DeKalb County School District

SP5FACCON .36035.GENCONTR . Routing/Transmittal Form

**THE DEKALB COUNTY BOARD OF EDUCATION
CONSTRUCTION CONTRACT CHANGE ORDER**

Project Name:	DeKalb High School of Technology-South Major Building Systems Replacement
Project No.:	360-35
Change Order No.:	003
Date:	September 11, 2024

ELECTRICAL FLOOR PLAN - POWER & FIRE ALARM - MAIN LEVEL
 E-302

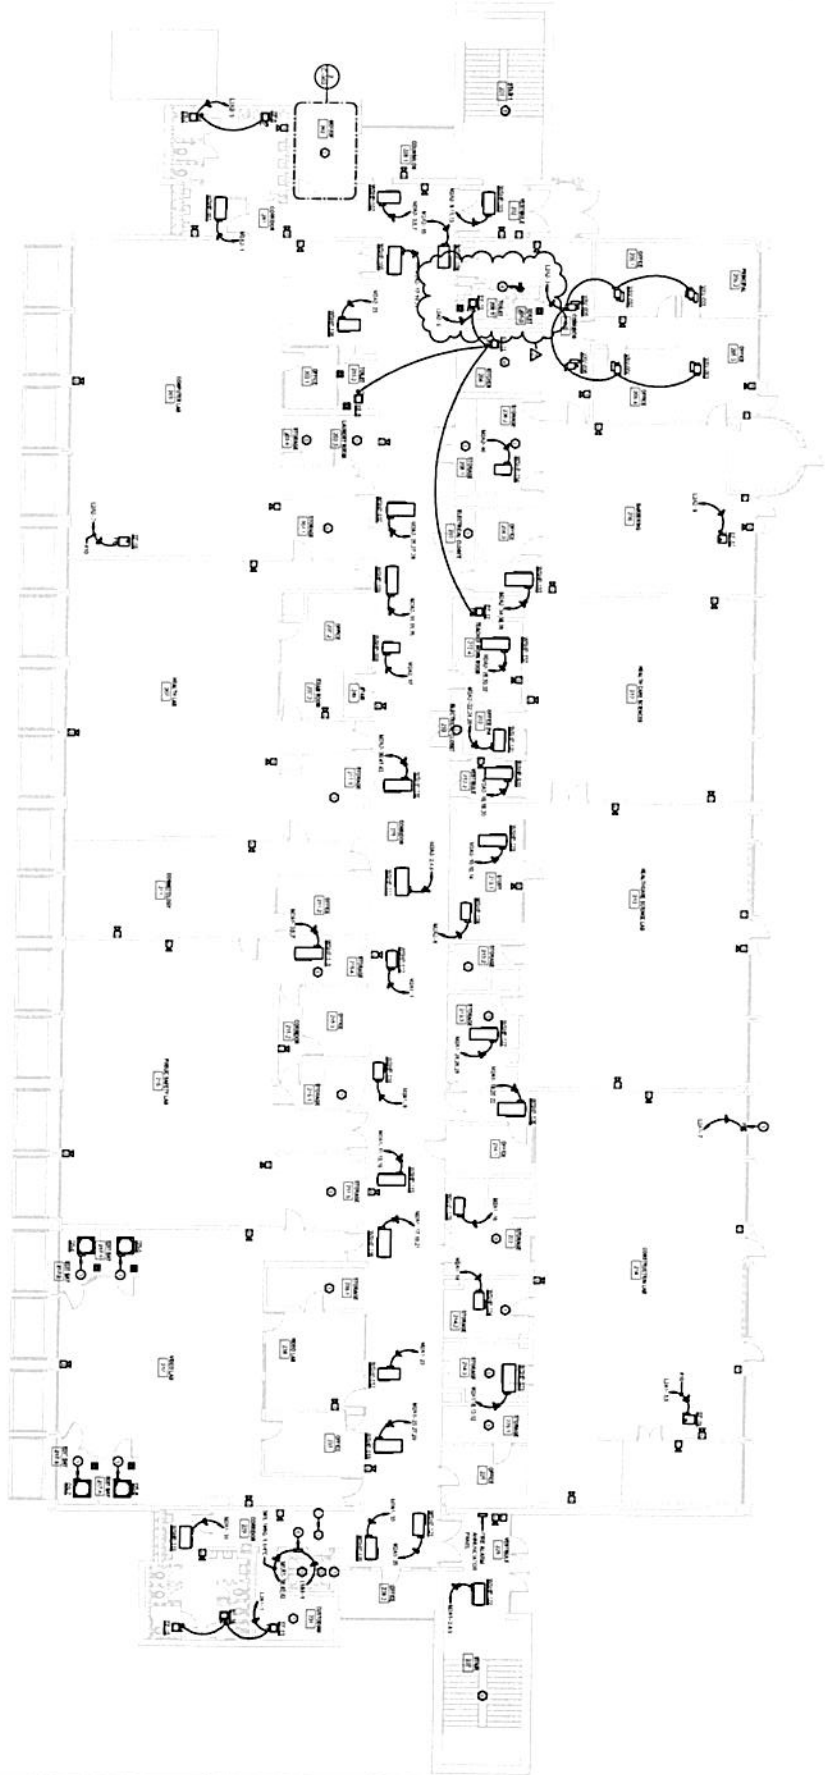
- Added Light fixtures in ASI #1.
- Move MSB, secondary feeder, branch panel feeders, and existing feeders to new MSB location.
- Deducted original MSB feeder.

RFI #29: Wheelchair Lift Power Requirements

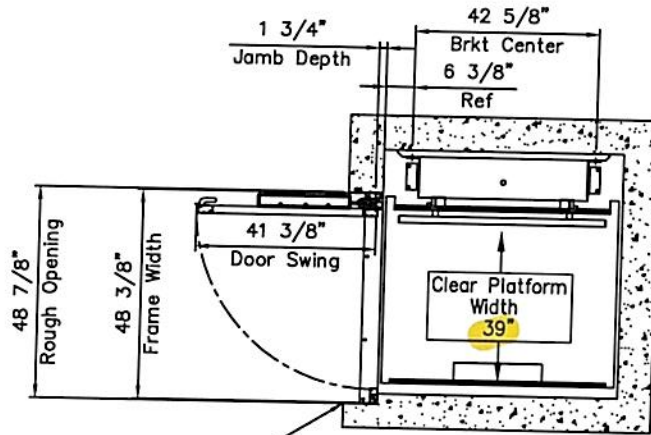
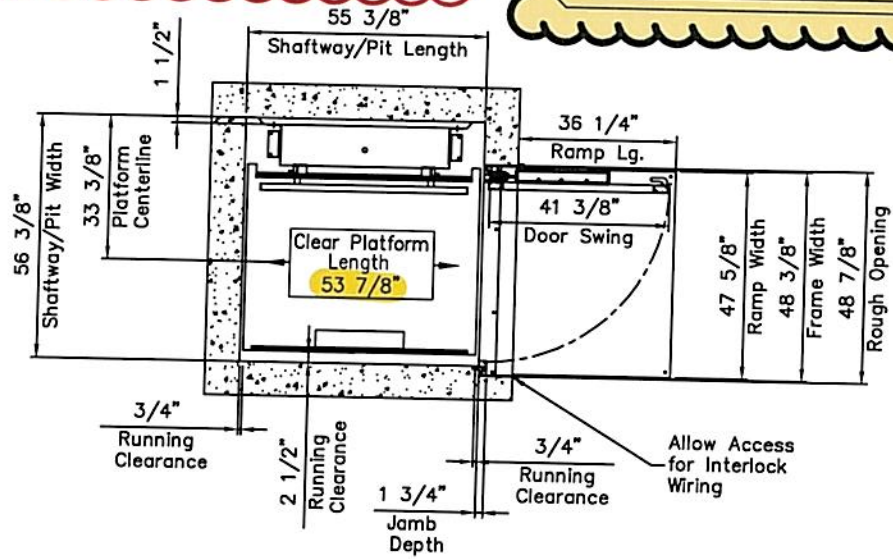
REF: E-301, A-113, Submittal 14 42 00 01 - Midvale Wheelchair Lift

As shown on A-113, a new wheelchair lift is to be installed at the Stage. The electrical main floor power plan, Sheet E-301 does not provide power requirements for the new wheelchair lift. The new lift will require a 120V/ 1-Phase 60Hz dedicated circuit to be supplied.

Please provide power requirements and location for the new wheelchair lift at Stage 131.3.

Circuit lift to Panel P1A1 in the main Mechanical room.
 Response By: Jeff Williams, Bolden-Williams & Associates, Inc.
 Date: 5/13/2024

DEDICATED CIRCUIT SUPPLIED BY OTHERS:
 120 VAC / 1 PHASE - 60 Hz.
 Conduit and devices to suit local codes and
 a recommended 15 amp. dedicated circuit.
